Re: **Docket No. 521 – Application of Tarpon Towers III, LLC and Cellco Partnership d/b/a Verizon Wireless for a Certificate of Environmental Compatibility and Public Need for the Construction, Maintenance and Operation of a Wireless Telecommunications Facility at 1021-1041 South Main Street in Cheshire, Connecticut**

RESPONSES OF CELLCO PARTNERSHIP D/B/A VERIZON WIRELESS TO
CONNECTICUT SITING COUNCIL INTERROGATORIES (SET ONE)

ATTACHMENT 2

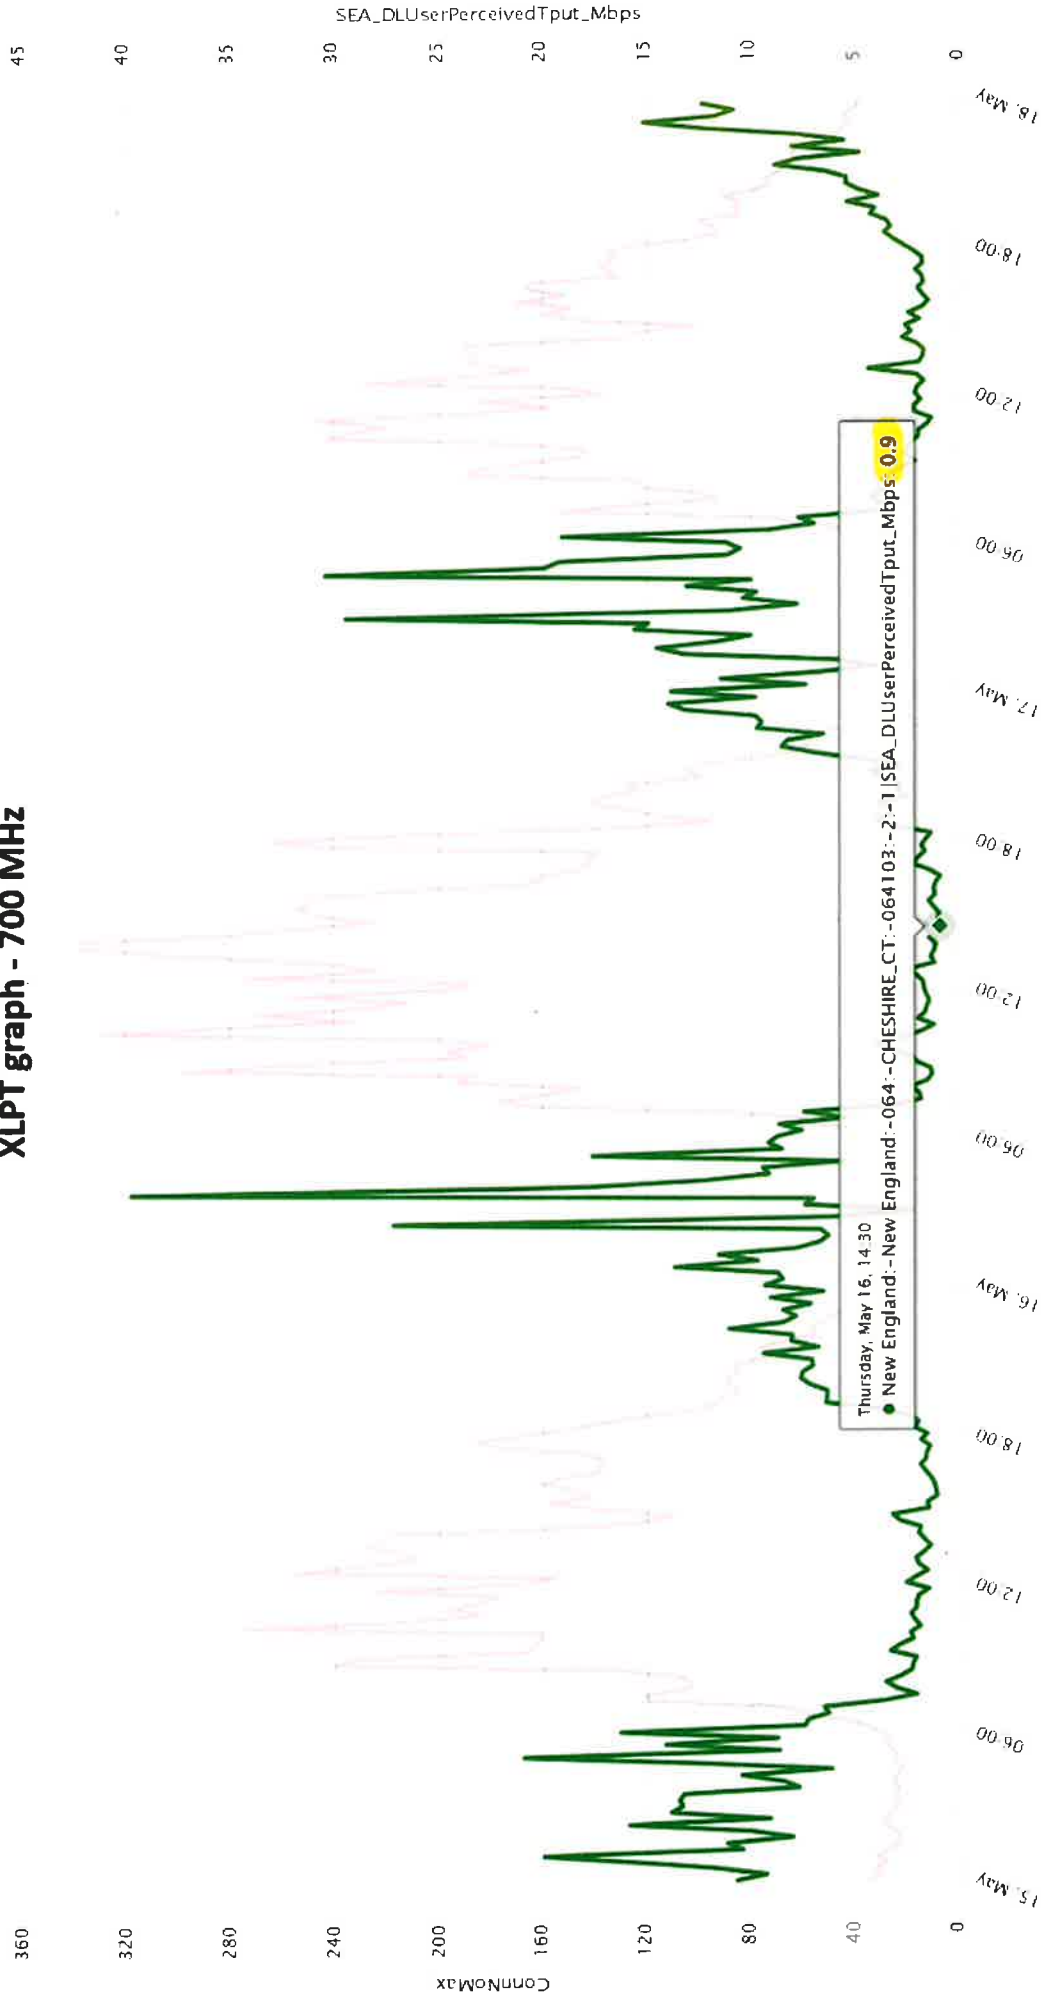
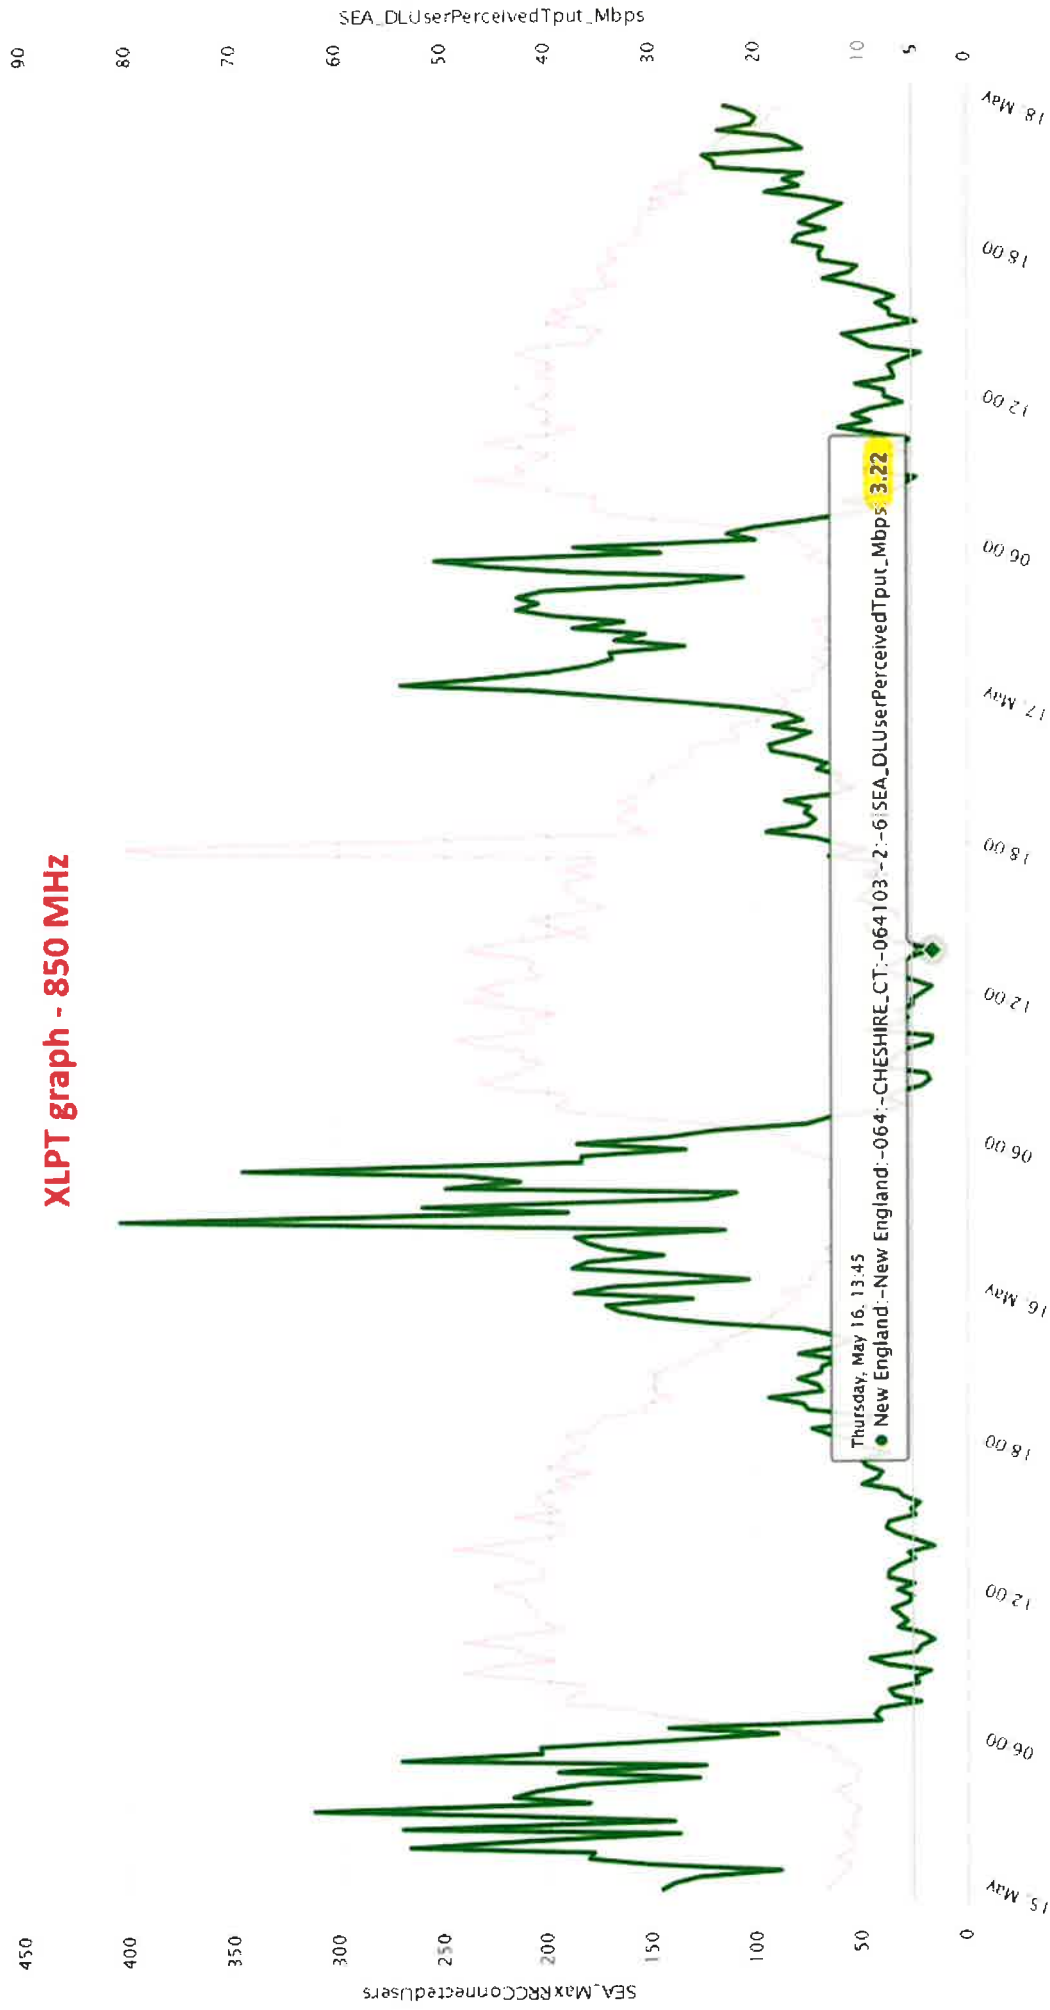
Does Cellco have any statistics on dropped calls and/or ineffective attempts in the vicinity of the proposed facility? If so, what do they indicate? Does Cellco have any other indicators of substandard service in this area?

Today, Cellco measures the user experience based on the data speeds (Downlink User Perceived Throughput) delivered to its users and has established a minimum of 5Mbps (Megabits/second) standard for its service to be considered "reliable". To illustrate, Attachment 2 to these responses includes "XLPT graph_700 MHz" and "XLPT graph_850 MHz" which show the data speeds delivered to Cellco's customers for the days (all day) of May 15 through May 18, 2024 for the congested CHESHIRE CT Beta sector 700MHz and 850MHz frequencies. These graphs show that there are a high number of customer connections (red lines) during peak

daytime hours (6AM to 6PM); and the data speeds delivered to the users during that time is under the 5Mbps standard (as low as 0.9Mbps for 700MHz and 3.22Mbps for 850MHz) resulting in the provision of unreliable service. Included in Attachment 3 is a “Distance Histogram” which shows the amount of traffic/customer connections handled by the CHESHIRE CT Beta sector on May 17, 2024 (24hrs) at its 700MHz and 850MHz frequencies. This histogram indicates that more than 50% of the traffic currently on the CHESHIRE CT Beta sector is within two miles of that site, indicating that the proposed Cheshire DT facility is appropriately located (within approximately 1.5 miles east of the CHESHIRE CT facility) to offload the congested CHESHIRE CT Beta sector on its 700MHz and 850MHz frequencies.
